DOT HS 812 201

Response to Peer Review Comments: Commercial Medium- and Heavy-Duty Truck Fuel Efficiency Technology Study

Reports 1 and 2

Suggestions on analyzing MD simulation data
Results shown for WHVC – 50% load

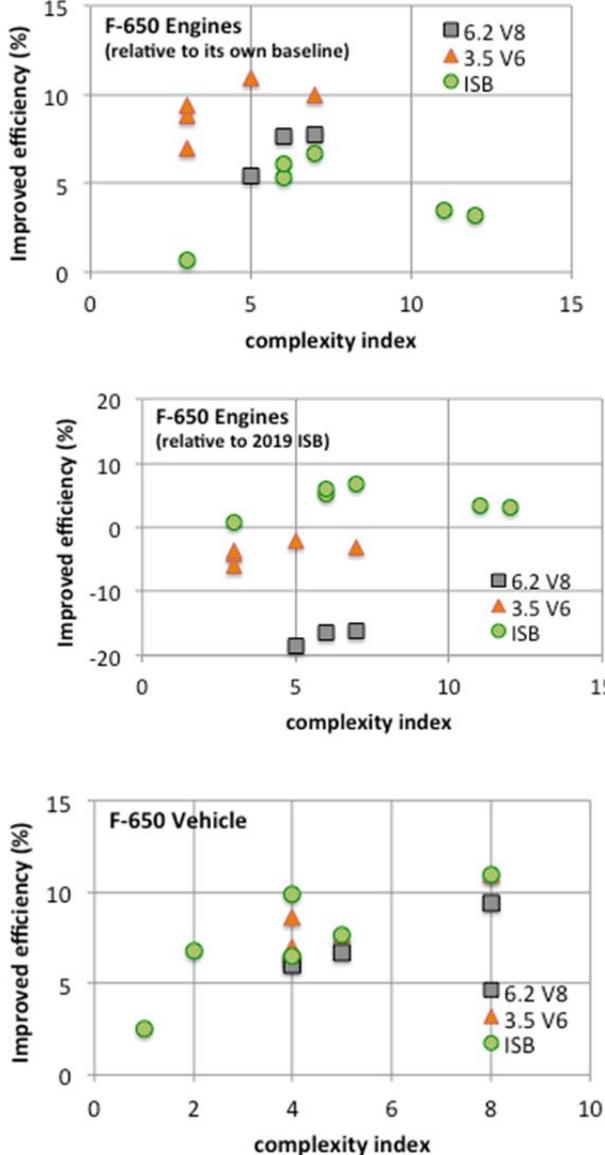
Comment

Response
